UNITED STATES PATENT AND TRADEMARK OFFICE

APPLICATION NO.	FILING DATE	FIRST NAMED INVENTOR	ATTORNEY DOCKET NO.	CONFIRMATION NO.
09/750,474	12/28/2000	William J. Harrison	ACS-55966 (26991)	6584

Office Action Summary

DETAILED ACTION

FIG. 7 (6,273,910)

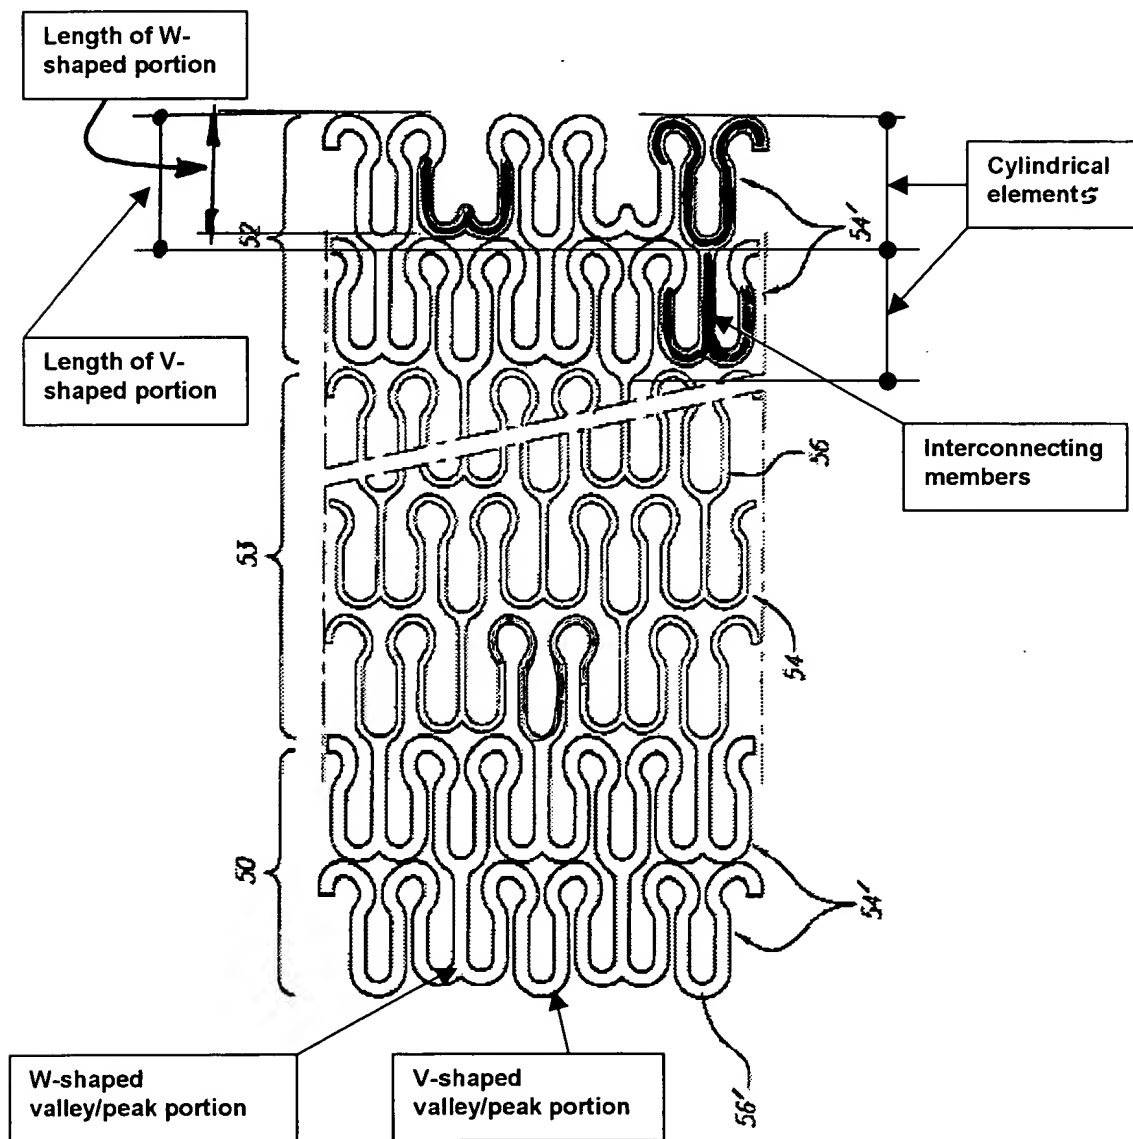
2. Claims 1-7, 11, 17-19, 21 and 23 are rejected under 35 U.S.C. 102(e) as being anticipated by LIMON (6,273,910).

LIMON (Figs. 1-7, especially Fig. 7 as shown on page 2, this office action) discloses a stent 54 (expanded by balloon, Fig. 2) having cylindrical elements, interconnecting members, W-shaped valley/peak portions, V-shaped valley/peak portions. W-shaped portions are shorter in longitudinal length than V-shaped portions. LIMON (Fig. 4) also discloses at least four V-shaped peaks/valley portions, W-shaped peaks/valley portions.

FIG. 4 (6,066,169)

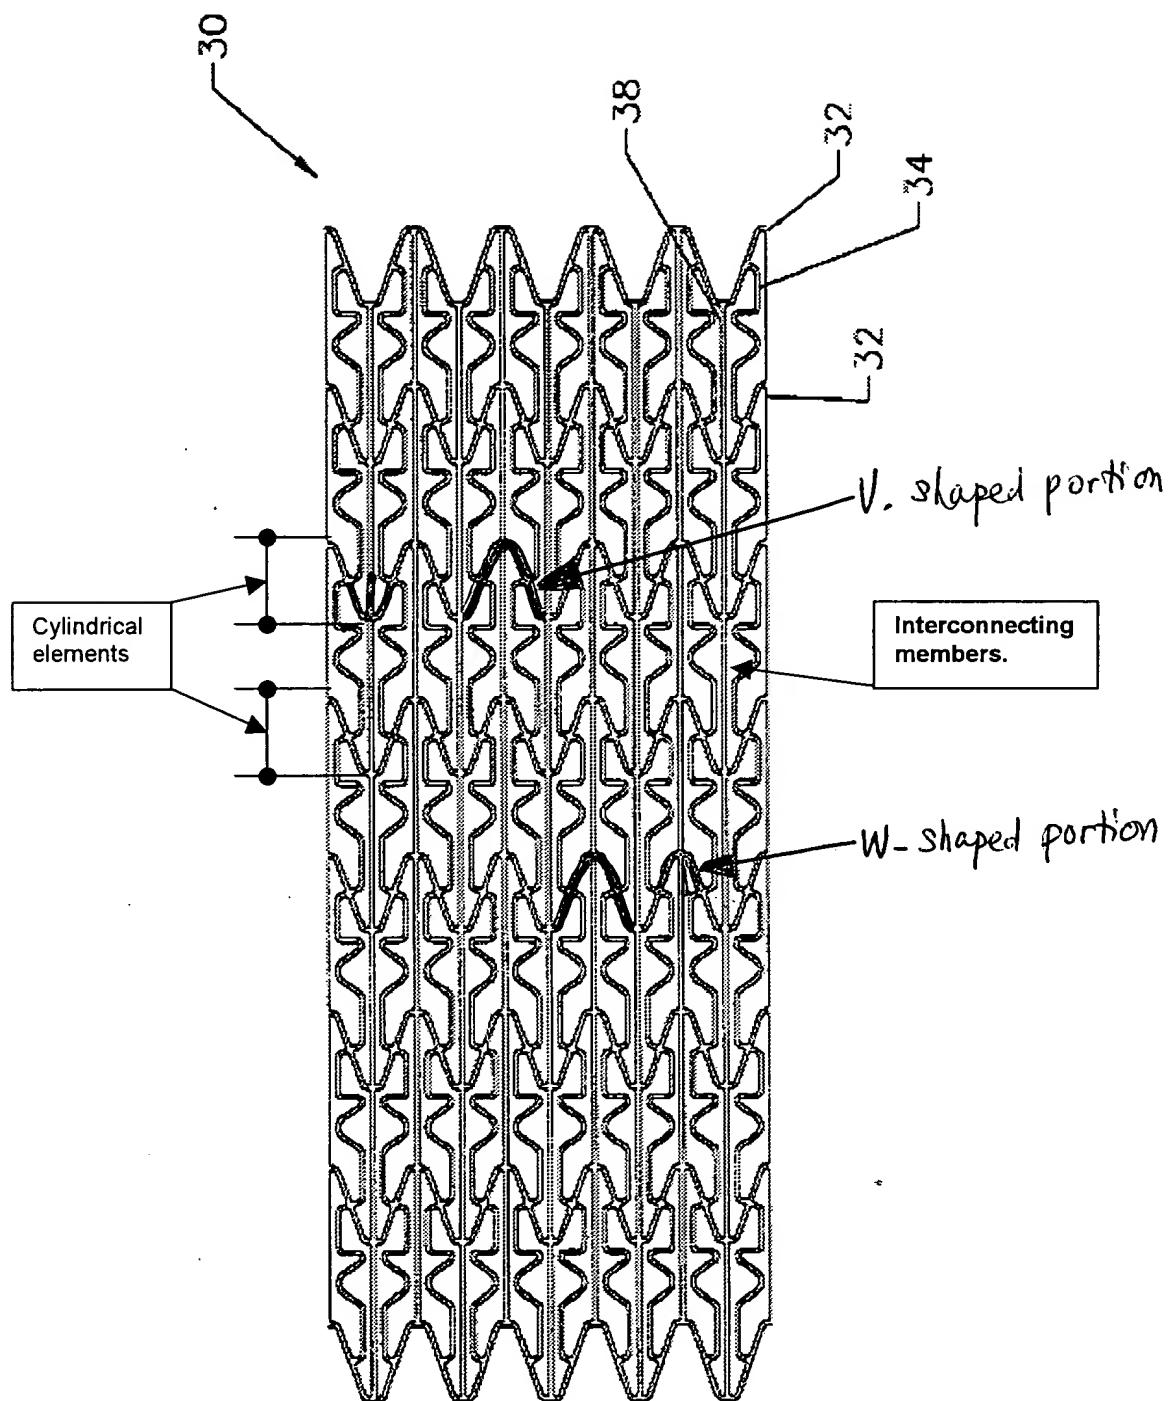
3. Claims 1, 8-10, 12-16 are rejected under 35 U.S.C. 102(e) as being anticipated by McGUINNESS (6,066,169).

McGUINNESS (Fig. 1-5, especially Fig. 4) discloses a stent having cylindrical elements, interconnecting members, W-shaped valley/peak portions, V-shaped

valley/peak portions. McGUINNESS (Fig. 4) shows each cylindrical element has at least two adjacent peak portions (one is V-shaped portion and one is W-shaped portion) which have differing longitudinal length and at least two adjacent valley portions (one is V-shaped portion and one is W-shaped portion) which have differing longitudinal length. Notice that V-shaped portions and W-shaped portions are highlighted as shown on page 3, this office action for correctly identifying the different elements as recited in the claims.
